METROPOLITAN GOVERNMENT OF NASHVILLE AND DAVIDSON COUNTY

STAFF RECOMMENDATION 2302 Belmont Boulevard December 19, 2018

Application: New Construction—Addition and Detached Accessory Dwelling Unit

Applicant: Martin Wieck, Nine12 Architects

PHOTOGRAPHS

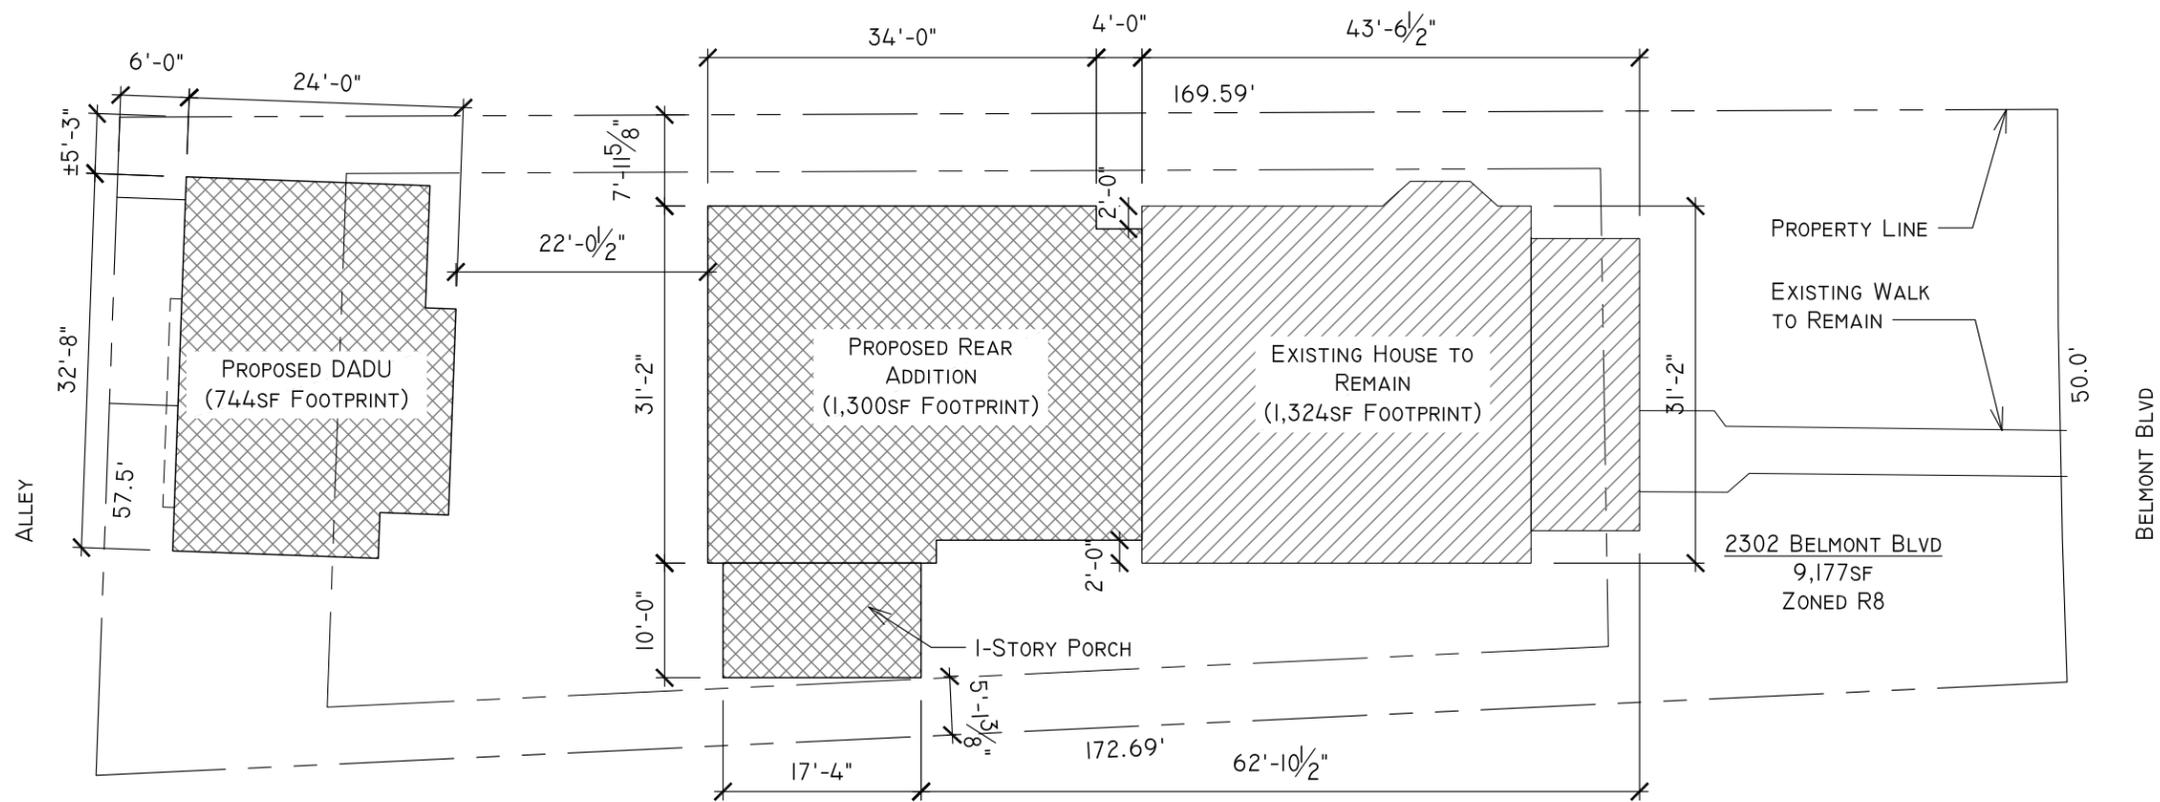
Demolition: An existing non-historic addition on the rear of the house will be demolished to accommodate the new addition (Figure 2). The section to be removed is not original, and does not contribute to the historic character of the house.

The plans show that a door on the left side of the building, towards the rear, will be replaced with a paired window opening, matching the opening above it (Figure 3). Changing the dimensions

and/or location of openings is partial-demolition and is generally not appropriate. However, in this case it is not clear if the door is original, and even if it is, it is located towards the rear of the house, not highly visible from the street.

Staff finds that the proposed partial demolition meets Section V.B.2 for appropriate demolition and does not meet section V.B.1 for inappropriate demolition.

ELEVATIONS

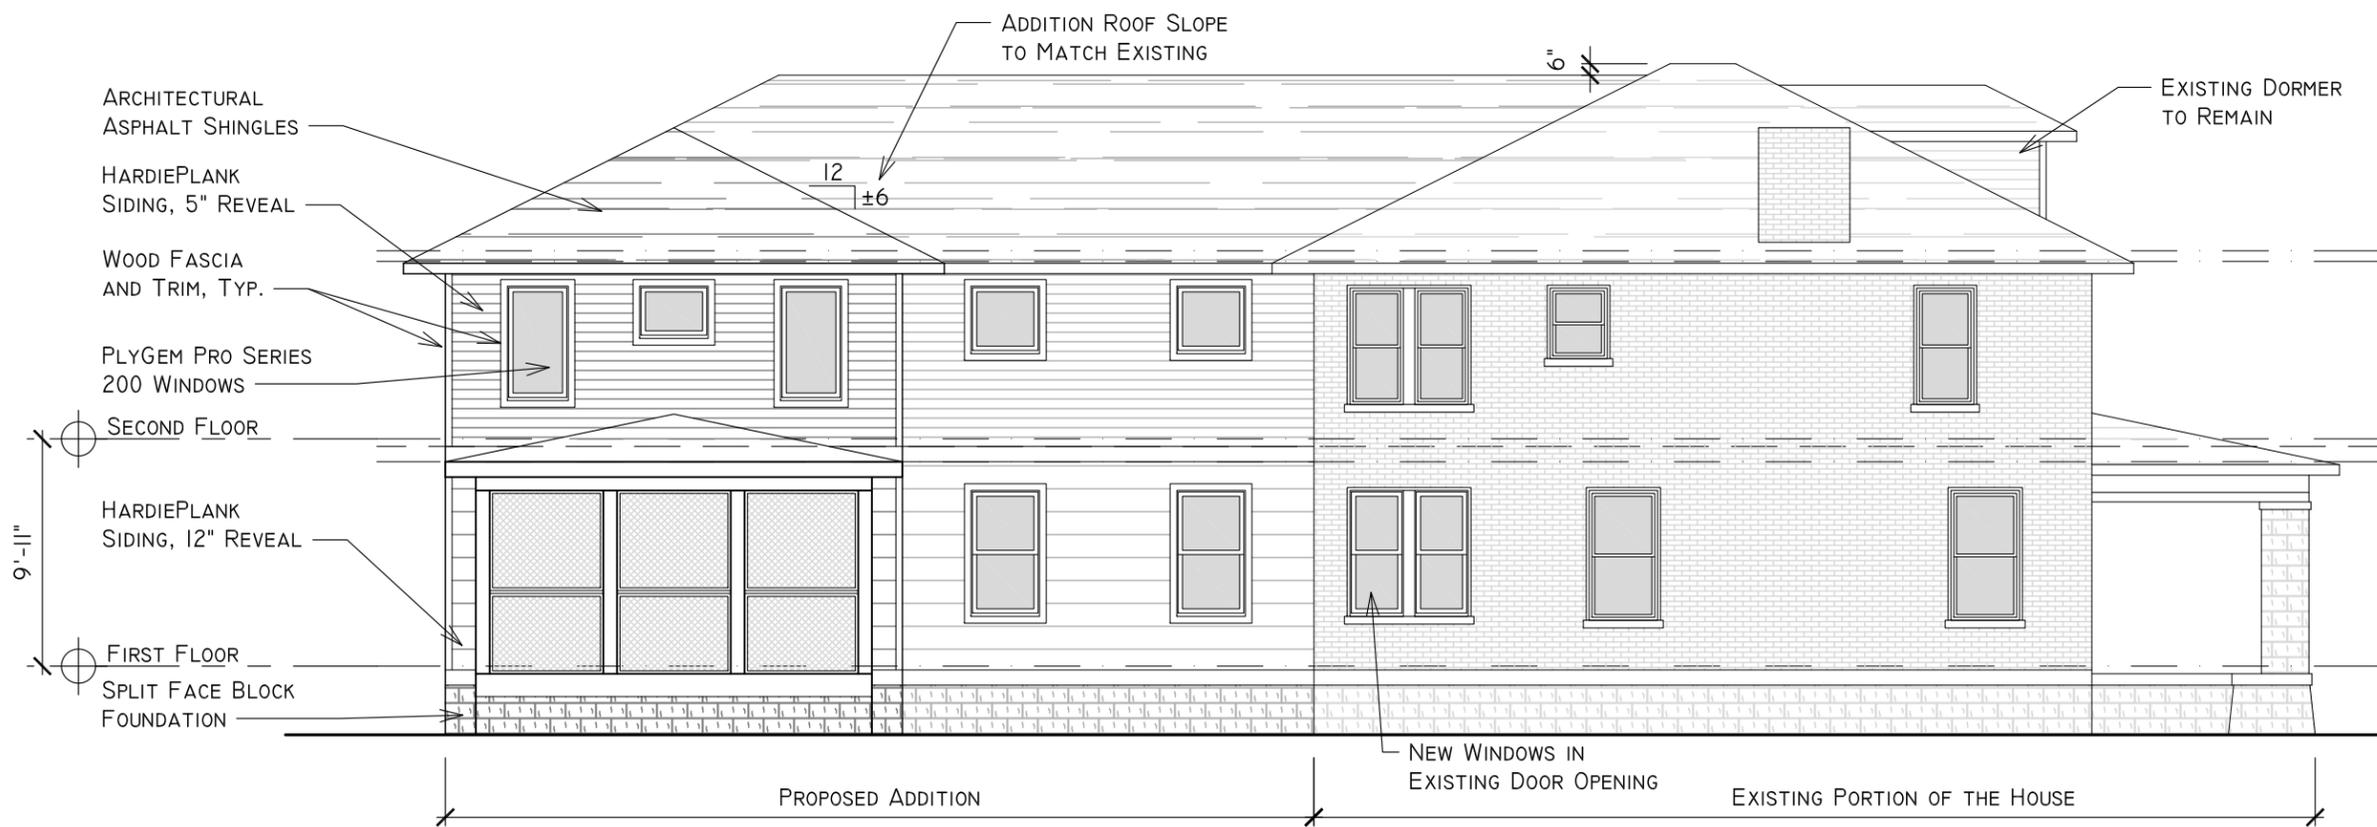
Location & Removability: The new addition will be on the rear of the historic house, which is an appropriate location. It will be two-stories tall, with a one-story wider element that is pushed back nineteen feet (19') from the back wall of the house. The addition is inset a minimum of two feet from each of the back corners of the house, distinguishing it from the historic house. The addition's roof ties into the historic house's roof six inches (6") below the historic house's roof. The addition's inset from the back corner and offset from the roof ensures that if it were to be removed in the future, the historic house's main form, proportion, and details would remain intact. Staff therefore finds that the project meets sections II.B.2.a and II.B.2.e of the design guidelines.

Design: The proposed addition's design is compatible with the historic house. Its roof form, fenestration pattern, and height and scale are all compatible with the historic structure. At the same time its separate roof form, modern materials, and insets distinguish it as a newer portion of the house. Staff finds that the proposed design meets Sections II.B.2.a and II.B.2.f of the design guidelines.

Height & Scale: The proposed addition is largely two stories, which is appropriate because the historic house is two-and-a-half stories. The ridge height will be between six inches and three feet (6"-3') lower than that of the historic house. The foundation and eave heights of the addition will match those of the historic house. The addition is inset two feet (2') from each of the back corners. On the right side, after a depth of four feet (4'), the addition steps back out to match the width of the historic house.

On the left side, after a depth of eighteen feet (18'), the addition steps back out and extends ten feet (10') wider than the historic house. The design guidelines state that wider additions "*may be appropriate when the building is narrower than 30' or shifted to one side of the lot.*" In this case, the house is shifted to the right side of the lot so that it is approximately six feet (6') from the right side property line and thirteen feet (13') from the left side property line. The house is a little over thirty feet (30') wide at thirty-one feet, two inches (31'2"). Although the house is one foot, two inches (1'2") wider than what the design guidelines state is appropriate for wider additions, staff finds that the proposed wider portion of the addition is appropriate for several reasons. It is located over sixty feet (60') back from the front of the house and ninety-six feet (96') back from

the sidewalk, reducing its visibility and its impact on the historic character of the house and neighborhood. Also, it is just one story in height and significantly shorter than the historic house, and it is a screened porch, open in nature. In addition, the lot is angled on the left side, so that the lot widens on the left side from the front to the back, providing more room for a side addition. Finally, the amount of the historic house that extends wider than the thirty-feet of width recommended by the design guidelines is negligible.

Roof form: The addition has a hipped roof form with a 6/12 slope. This matches the historic house’s roof form and meets Sections II.B.1.e. and II.B.2. of the design guidelines.

Proportion and Rhythm of Openings: As mentioned under partial demolition, the applicant plans to change a door opening on the existing house, left façade, into a paired window opening. The windows on the addition are generally twice as tall as they are wide. There are no large expanses of wall space without a window or door opening. Staff finds the project’s proportion and rhythm of openings to meet Section II.B.1.g. and II.B.2. of the design guidelines.

DADU ELEVATIONS

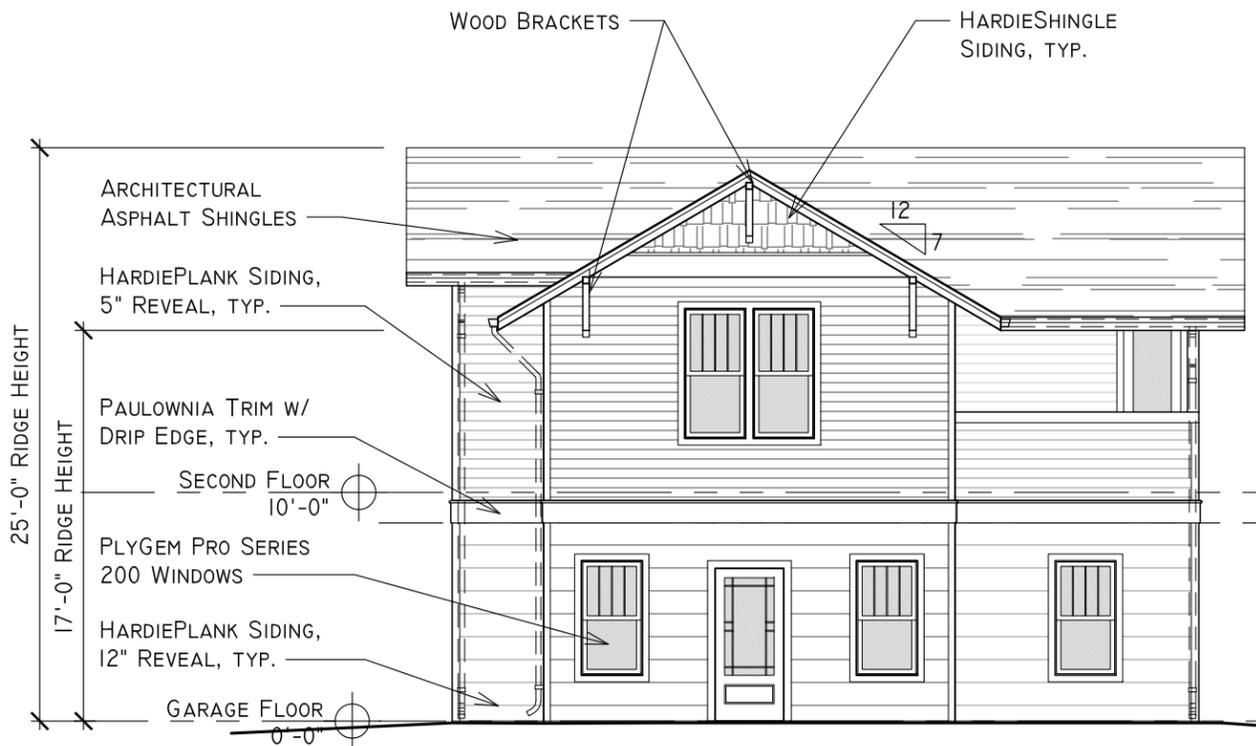
Outbuildings: The applicant proposed a two-story outbuilding that will be used as a Detached Accessory Dwelling Unit.

Proposed Element	Proposed Form	Typical of district?
Primary Form	Cross gable	Yes
Primary Roof Pitch	7:12	Yes

These roof the forms and pitches are similar to historic outbuildings, therefore Staff finds that the project meets section II.B.1.i.1 of the design guidelines and the DADU ordinance, Section 17.16.030.G.

Design Standards: The outbuilding has a simple and modern design that is appropriate for outbuildings. The outbuilding’s roof form, detailing, and form do not contrast greatly with the primary structure, and the building will be appropriately located at the rear of the lot. Staff finds that the outbuilding meets section II.B.1.i.2. of the design guidelines and the DADU ordinance, Section 17.16.030.G.
